ADDENDUM:

3

TODAY'S DATE: 04.07.22

PROJECT NAME: Gustaves Manor Envelope and Roof

16 WINDOW ASSEMBLY

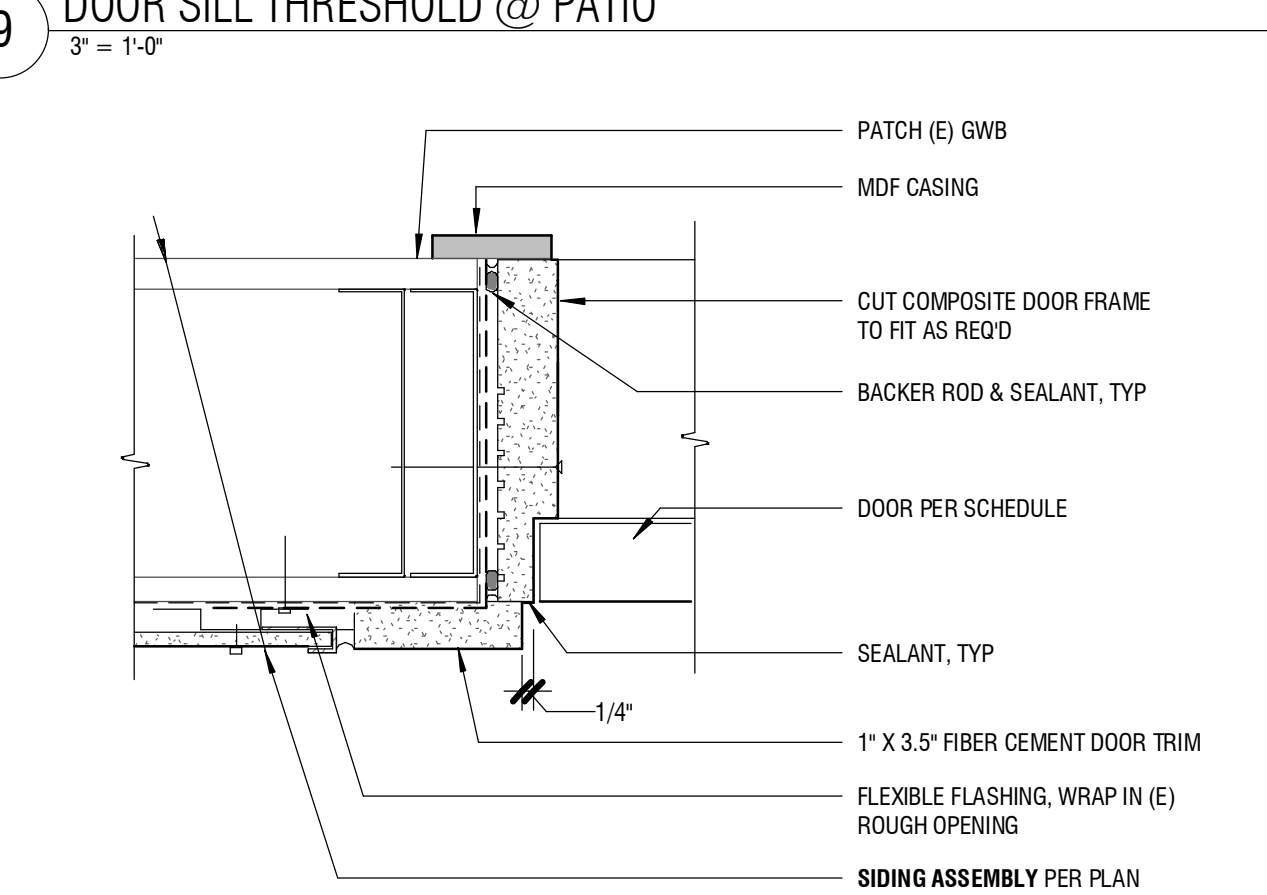
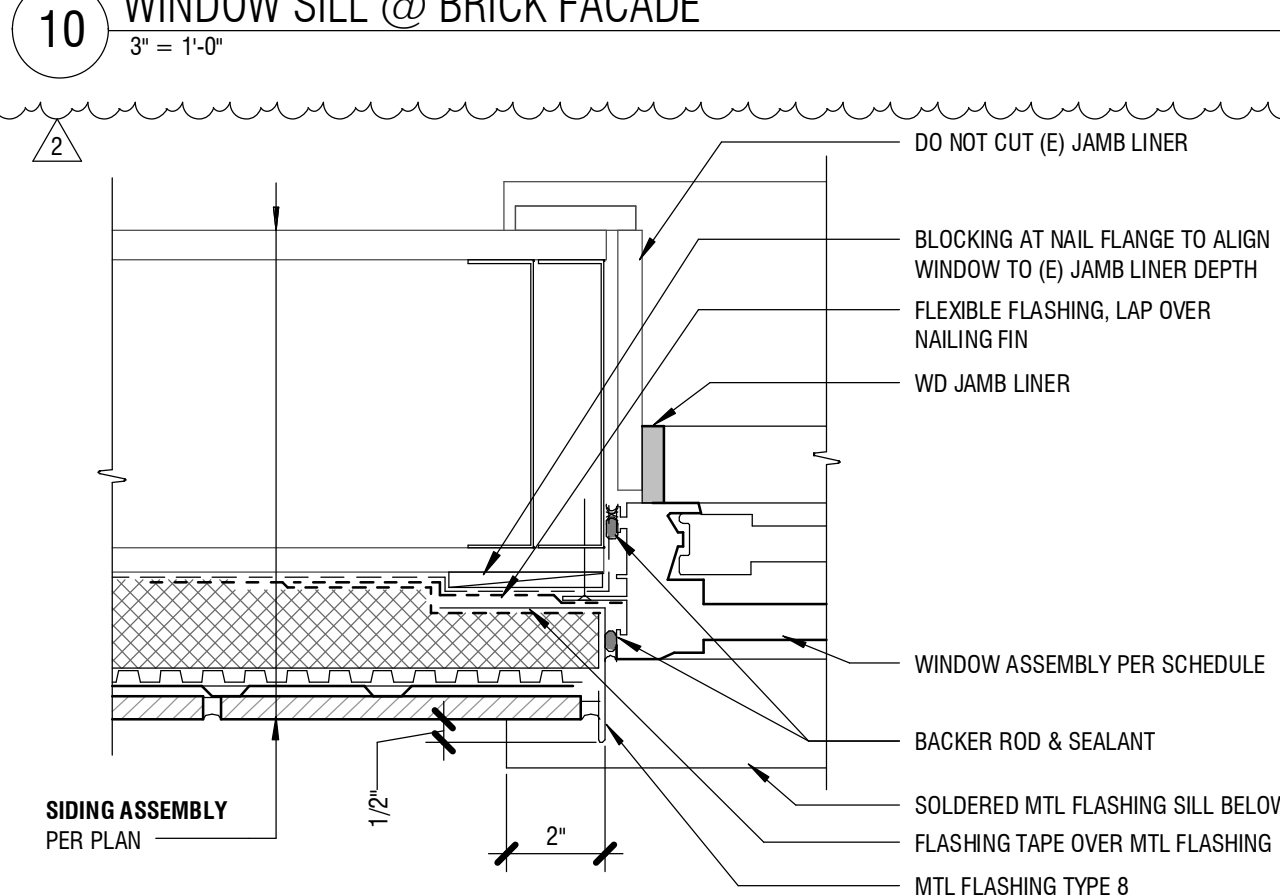
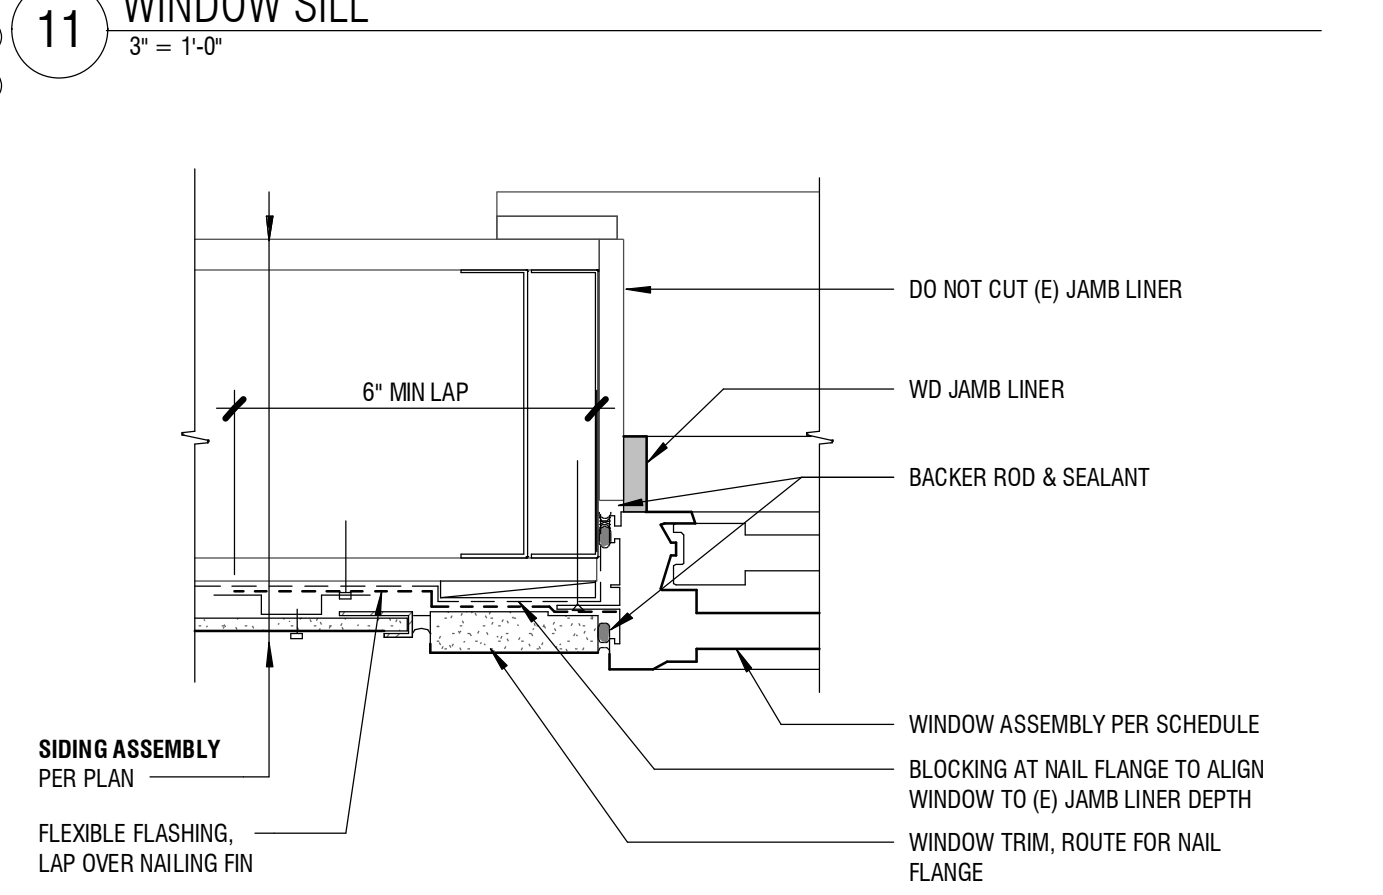
Details 5/A4.1 and 9/A4.4 show the individual “Brick it” bricks to be mitered at inside and outside corners. Please confirm this detail.

Per 5/A4.1 and 9/A4.4, inside and outside corner bricks are to be mitered. If the manufacturer provides an appropriate corner brick shape (Brick It offers a 90-degree corner) this may be used in lieu of mitering.

SUBSTITUTION REQUEST

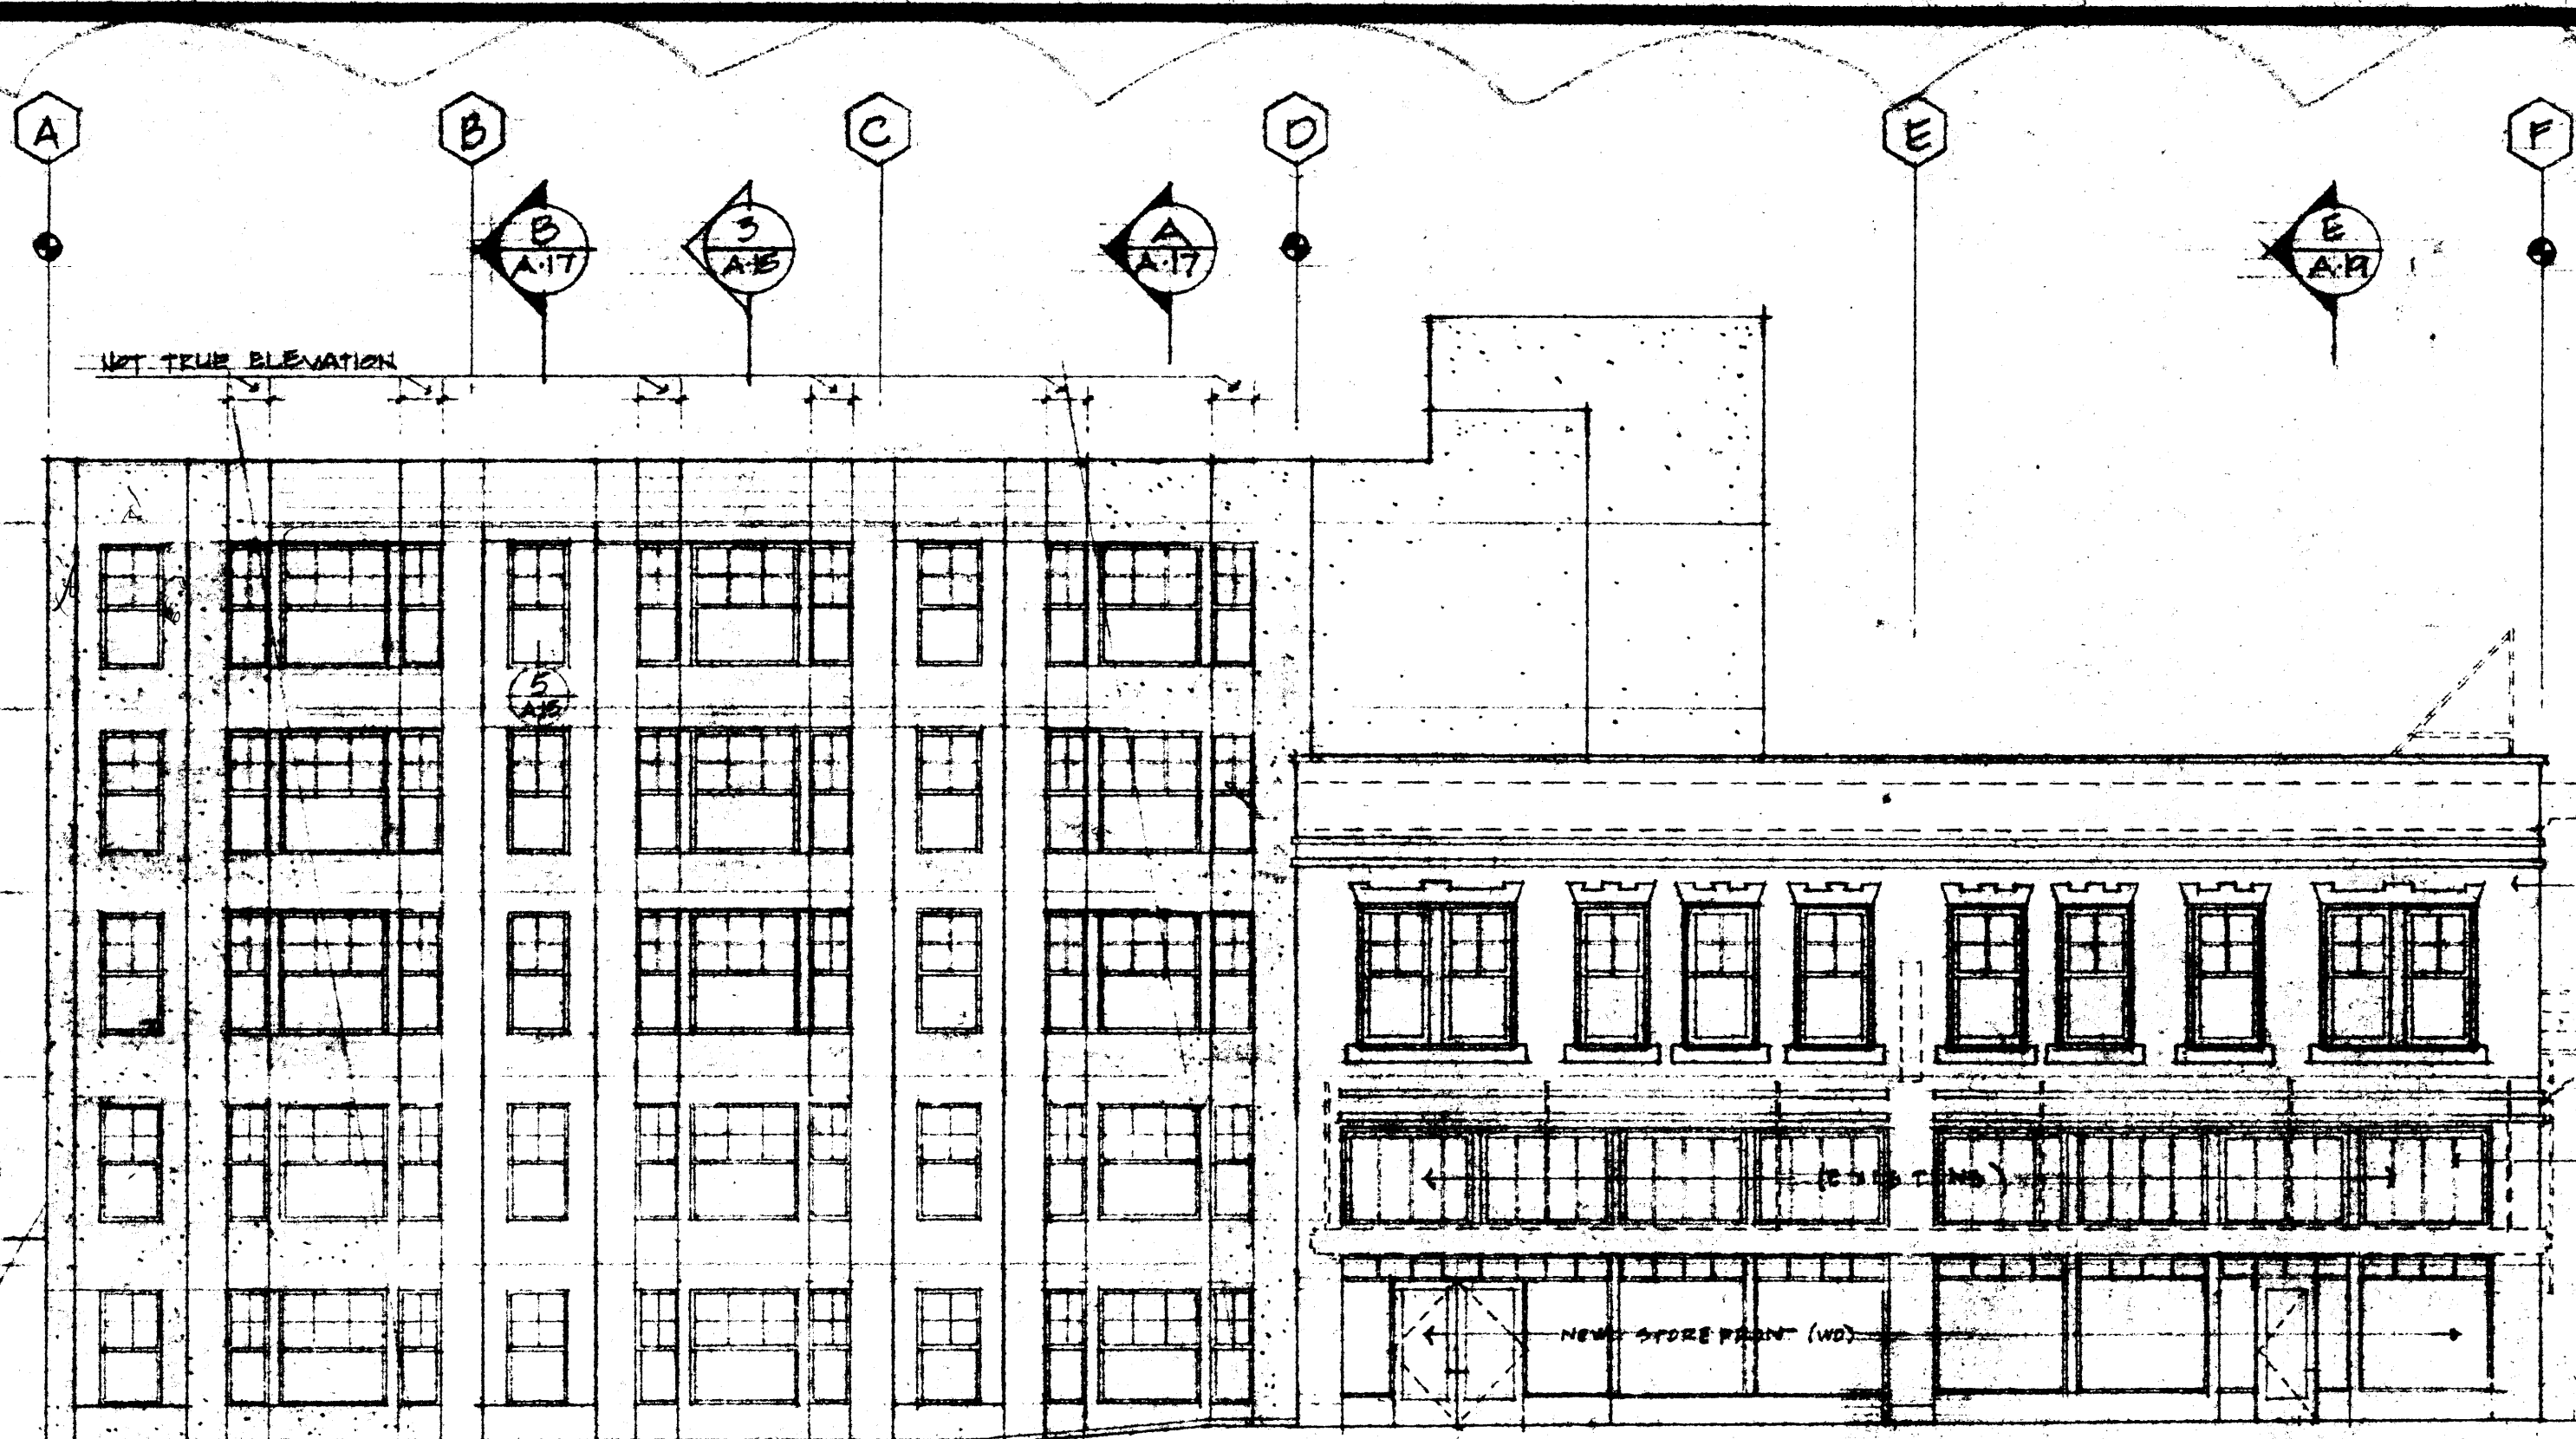
Proposed Substitution: Have Rooftop Anchor, Inc. listed as an acceptable manufacturer
Manufacturer: Rooftop Anchor, Inc.
Address: 875 S 600 W, Heber City, UT 84032 Phone: 801-839-2900
Trade Name: Fall Protection Systems & Window Washing Systems Model No.: _____
Installer: MK Fall Protection, Inc.
Address: PO Box 1432, Lake Stevens, WA 98258 Phone: 425-320-1490
History: ☐ New Product ☐ 2 - 5 years old ☒ 5 - 10 years old ☐ More than 10 years old

Differences between proposed substitution and specified product: Higher quality product hands-free pass-thru horizontal lifeline system with stainless steel cable and swaged terminations that allows users to move freely over anchor locations along the system while staying 100% tied-off. SS cable is more weather resistant and swages are load tested.

- ☐ Substitution approved - Make submittals in accordance with Specification Section 01 3300.
- ☒ Substitution approved as noted - Make submittals in accordance with Specification Section 0 13300.
- ☐ Substitution rejected - Use specified materials.
- ☐ Substitution Request received too late - Use specified materials.

Per Section 11 24 28 Fall Protection Systems, design and engineering for rooftop engineered fall restraint and fall arrest for worker safety on roofs is by the Contractor. In addition to being OSHA compliant, the system must also be WISHA compliant
